STAFF REPORT: 2/12/2025 MEETING REVISED 2/10/2025 PREPARED BY: J. ROSS

ADDRESS: 14528 ASHTON DRIVE APPLICATION NO: HDC2025-00024 HISTORIC DISTRICT: ROSEDALE PARK

SCOPE: REPLACE FRONT PORCH, ALTER DRIVEWAY AND WALKWAY

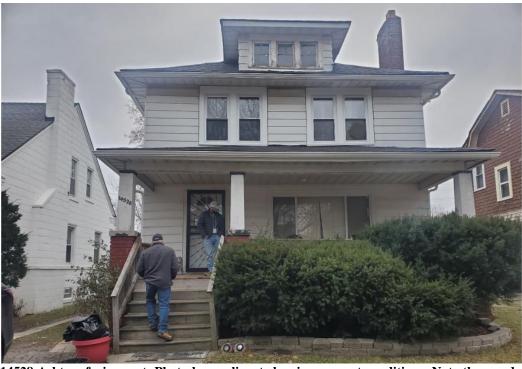
- The Rosedale Park Historic District was designated in 2008
- See the photos below and note the following:
  - The current front porch decking/floor, guardrails, handrails, skirting, and steps were added after the district was designated, in 2016 without Commission approval, per HDC files.

14528 Ashton porch, 2008 designation slide. Source, HDAB. Note the wood guardrails, steps, and flooring. The handrails (outlined in green) are metal while the guardrails (outlined in purple) are wood.

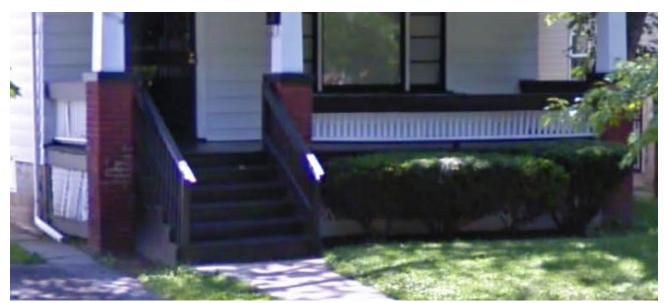
• As noted above and demonstrated in the below designation photos, the porch had wood guardrails and metal handrails at the time of the district's designation. The below Google Streetview image, taken in 2009, illustrates the dimensions, type, style, and material of the guardrails that were present at the time of designation and removed without HDC approval. Note that the metal handrails which appear in the designation photo appear to have been replaced without HDC approval with wood handrails by 2009. The wood guardrails were replaced in 2016 without HDC approval.

Note that the current application proposes to install aluminum guardrails and handrails at the
porch. Although wood would be the most appropriate material for the new handrails (along the
steps) in staff's opinion, aluminum handrailing as proposed would be a compatible/appropriate

treatment for this location as non-historic metal railing was present at the time of the district's designation. However, it is staff's opinion that the installation of metal guardrails (along the side and front at the perimeter of the porch deck) does not meet the Standards as the original elements/wood guardrails were significant character defining elements of the house and were removed in 2016 without HDC approval. Therefore, new wood guardrails that match the style of the historic railing that was present at the time of the district's designation is the appropriate treatment for this scope item.

- The porch's new guardrails (railing which lines the perimeter of the porch deck) shall be wood and match the style of the historic railing that was present at the time of the district's designation. The railing height shall be no higher than the minimum required by building code (36") because the railing height is a historically significant feature of the house. HDC staff shall be afforded the opportunity to review and approve the new railing design prior to the permit's issuance.
- New landscaping shall be planted to replace the shrubs at the front of the porch which shall be removed as a result of the proposed porch rehabilitation. HDC staff shall be afforded the opportunity to review and approve the new foundation plantings prior to the permit's issuance.
